Product Change Notice (PCN)

PCN Number: PCN-0381029R-01

Product(s) Affected: GF0668

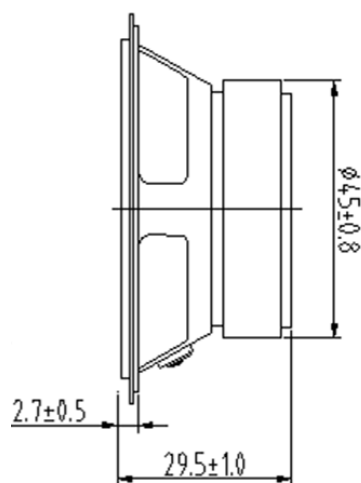
Description of Change: *SPL increased to 91dB, operating temperature range -20~60°C, brown gasket is now black, dimensional changes shown below:*
